# ALERT SERVICE BULLETIN

Service Bulletin No.: DA20-53-01A, Rev. 0

Title: Interference, Rudder Pedal/Foot

**Figure 1**

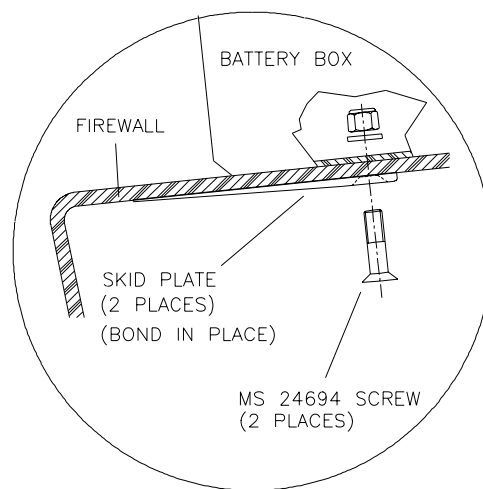
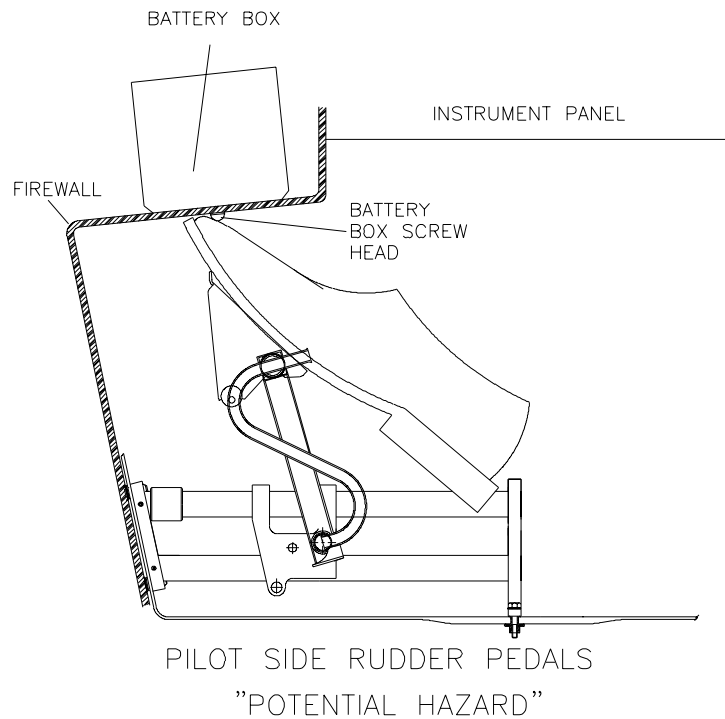
3. General: This service bulletin addresses the possibility of a jammed rudder control system. The toe of the pilots shoe could catch on the screw head(s) which mount the battery box to the firewall (See fig.1). The installation of skid plates and new mounting hardware prevent the above condition from occurring.

- 10.7 Apply a sufficient amount of DP110 epoxy adhesive (or equivalent 5 minute epoxy cement) to the skid plate face opposite the countersink. Install the skid plates using the hardware provided to locate the holes. **Ensure that the skid plates are oriented in the forward direction as shown in figure 1.**  
Reinstall the battery box. Tighten the screws to pull the skid plates tight to the firewall. Ensure the head of the screw does not protrude below the surface of the skid plate.
